Access Compliance Report

(Curb Ramps)

Intersection ID: 51704	Main Street: IKEA_BV	Cross Street: BROOKSIDE_LN	Location: SW
ADA ID: C4865909F210	Ramp Type: Perp	Initial Pass/Fail: Fail	Overall Compliance: No
Severity Score: 10			
Codes/Mitigation Info/Possible Solution		Field Measurements/Component Compliance

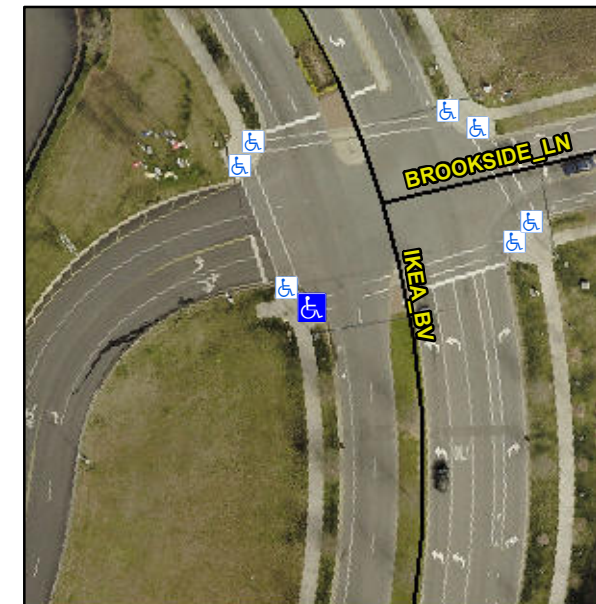
Not Found, R304.5.1, R304.5.3

Compliance	Description	Data	Compliance	Description	Data
N/A	Ramp Length (in)	96.0	Yes	Ramp Slope (%)	6.5
No	Ramp Width (in)	47.5	No	Ramp XSlope (%)	3.4
N/A	Flare Type LT	N/A	N/A	Flare Type RT	N/A
N/A	Flare Slope LT (%)	N/A	N/A	Flare Slope RT (%)	N/A
N/A	Flare Traversable LT?	N/A	N/A	Flare Traversable RT?	N/A
N/A	Landing Length (in)	N/A	N/A	DWS Provided?	N/A
N/A	Landing Width (in)	N/A	N/A	DWS Contrast?	N/A
N/A	Landing Slope (%)	N/A	N/A	DWS Length (in)	N/A
N/A	Landing X Slope (%)	N/A	N/A	DWS Full Width?	N/A
N/A	Landing Curb? (Y/N)	N/A	N/A	DWS Offset (in)	N/A
N/A	Shared Landing?	N/A			
N/A	Gutter Ponding?	N/A	N/A	Gutter Slope (%)	N/A
N/A	Gutter Lip Ht (in)	0.75	N/A	Gutter X Slope (%)	N/A
N/A	Painted X Walk1?	Yes	N/A	Painted X Walk2?	N/A
	X Walk 1 Direction	To E		X Walk 2 Direction	N/A
N/A	X Walk 1 Width (in)	72.0	N/A	X Walk 2 Width (in)	N/A
	X Walk 1 Slope (%)	2.0		X Walk 2 Slope (%)	N/A
	X Walk 1 X Slope (%)	3.1		X Walk 2 X Slope (%)	N/A

Remove & Replace Entire Ramp.
